**DOCKETED**

# **GREAT OAKS SOUTH BACKUP GENERATING FACILITY**

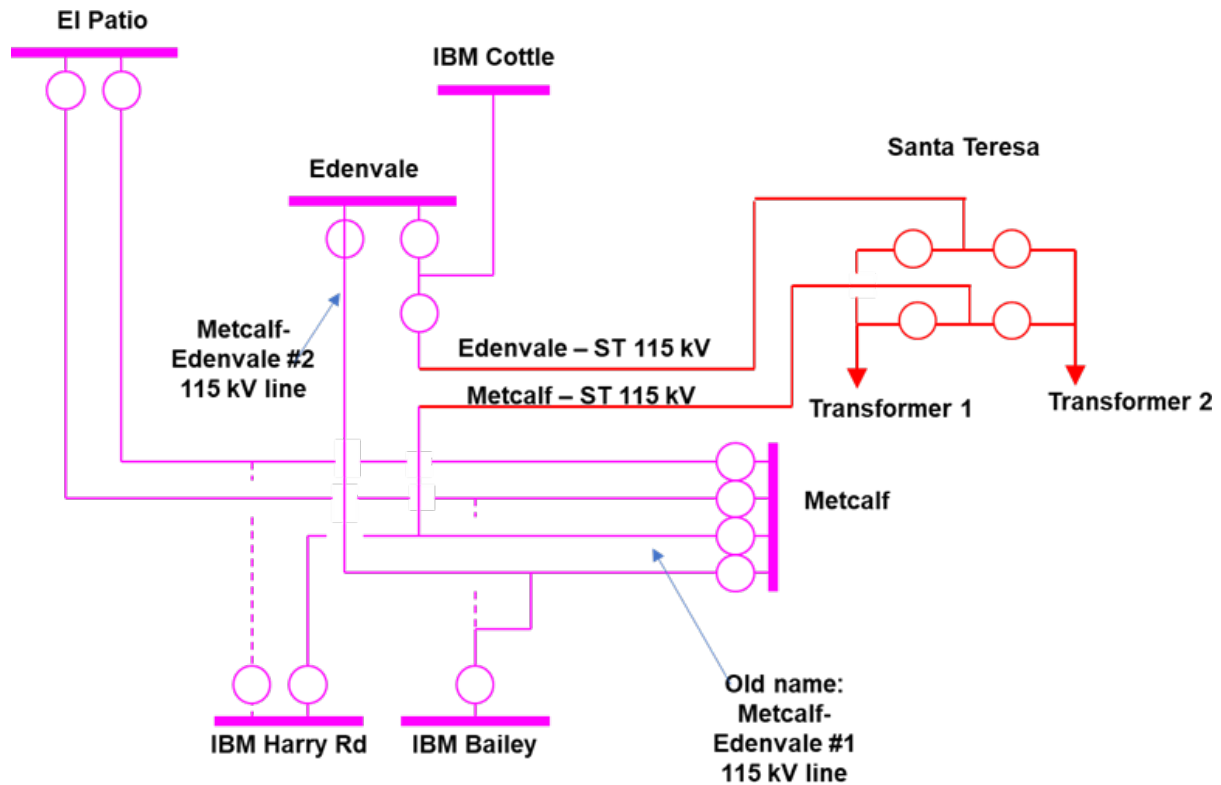
**1. PG&E will submit a clarification on how and when the second and third transformers be installed to serve the anticipated GOS load.**
